BRIEFING NOTES
Planning Committee – 18 January 2023

ITEM 02 - Land At Singapore Road And Green Man Lane Green Man Lane West Ealing W13 0SN - 223093HYBRID

Amendments to Recommendation

GROUND FLOOR BLOCK C

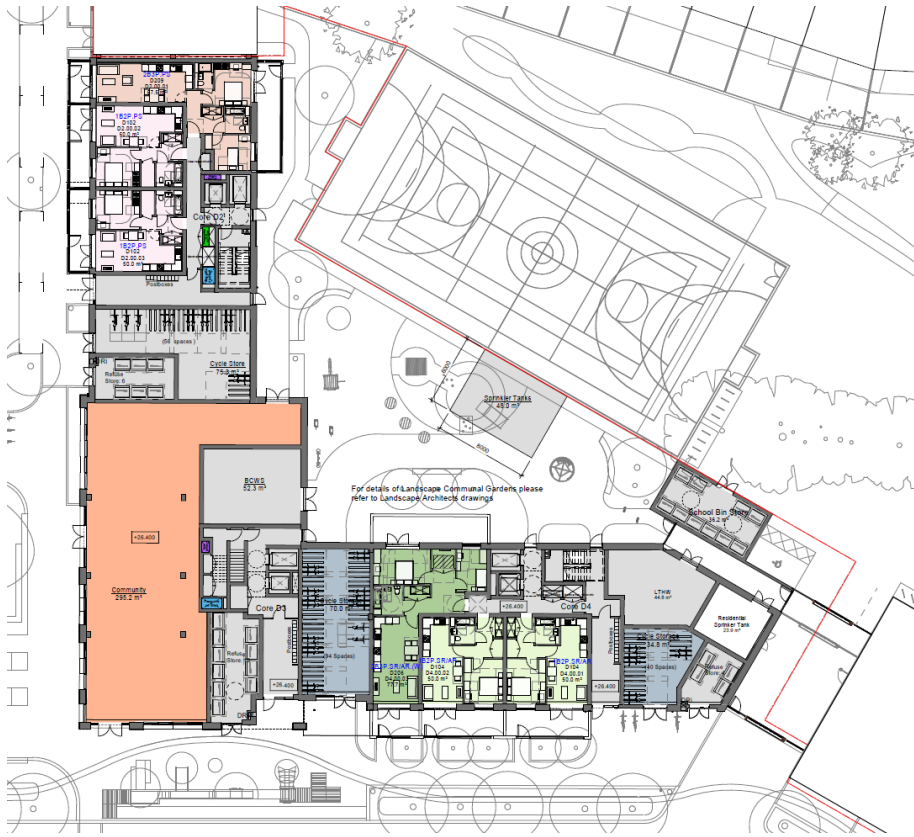
11. In response to this situation, the applicant (A2 Dominion) has demonstrated through sketch images that this new regulation may have the following potential impacts on the development as currently proposed:

Block C

Changes to the ground floor, requiring the redesign of cycle and refuse storage rooms to accommodate exit points for the secondary staircase. It is anticipated that this can be reasonably redesigned to ensure that the necessary cycle and refuse storage can be accommodated.

Sketch diagrams of all floors for Blocks C1 and C5 have been carried out, which demonstrate a second staircase could be accommodated by reducing a 2-bedroom flat on each level within each block to a 1-bedroom flat. This would result in a reduction of 28 habitable rooms of private market housing across the scheme, but no loss in the total number of units. Based on these indicative plans where changes are to occur, a summary of the potential impacts is succinctly shown in the table below.

GROUND FLOOR BLOCK D

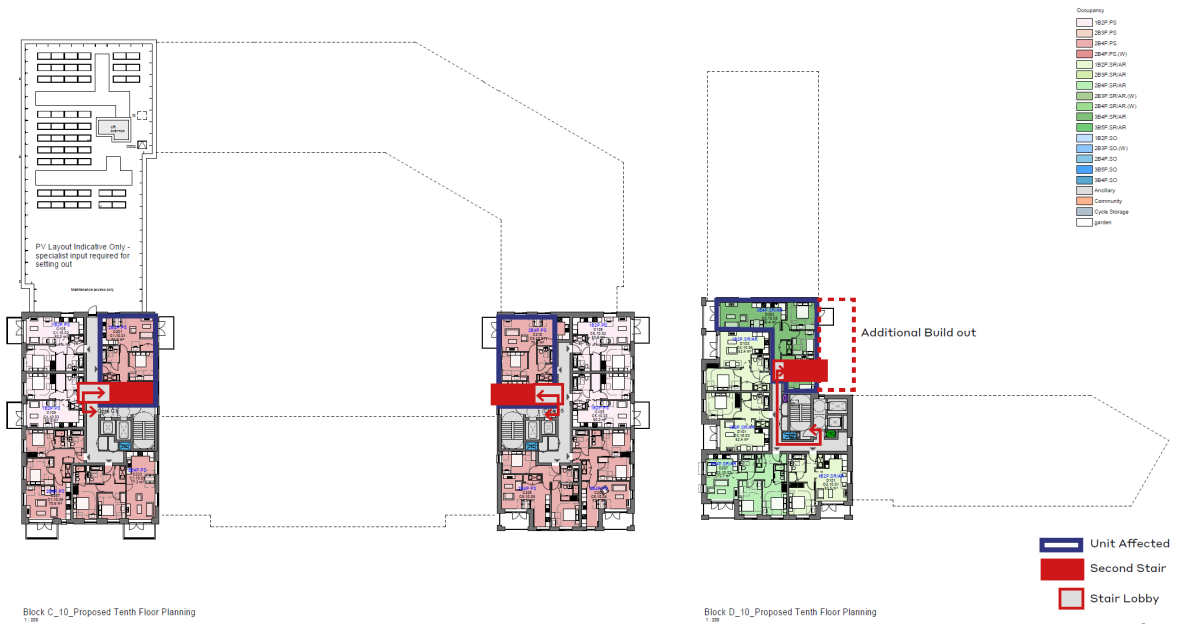
Block D

Changes to the ground floor, requiring the redesign of the cold-water storage to provide an exit point to the communal amenity area for the second staircase.

A second staircase could be provided through each level which would result in changes to the internal layout of a 3b4p flat on each level. There would be no loss of affordable housing units or habitable rooms, but this would likely result in a change to the footprint of the building, increasing one of the eastern walls by an 1 metre circa over all levels.
